**Technical Service Bulletin
TSB24-500-001**

APPLIES TO: This service bulletin applies to 2023 – 2024 model year, K1, K2, K3 and K4 model motor home chassis built between September 10, 2021 – October 12, 2023, equipped with an AD100 pedal control module and an ICM.

CONDITION: The switch used to adjust the brake and throttle pedal positions may work intermittently, or not at all.

CORRECTION: Replace the ICM

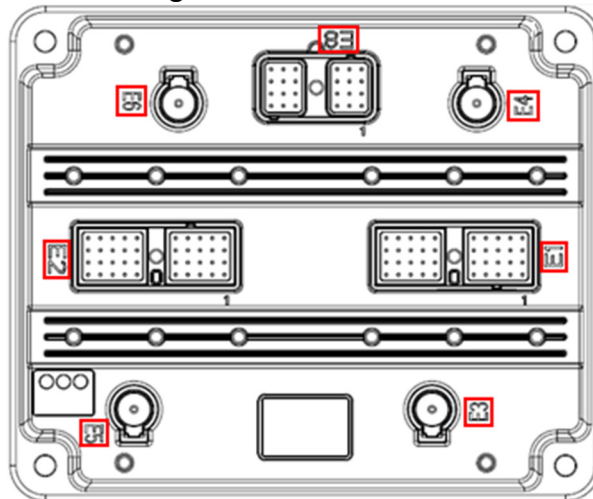
1. Ensure you have the following items for this repair.
 - a. M4 hex wrench
 - b. Socket wrench set
 - c. Pre-programmed replacement ICM
2. Turn off the chassis battery disconnect switch in the service center.
3. Locate the ICM behind the generator slide out on the driver side of the vehicle.
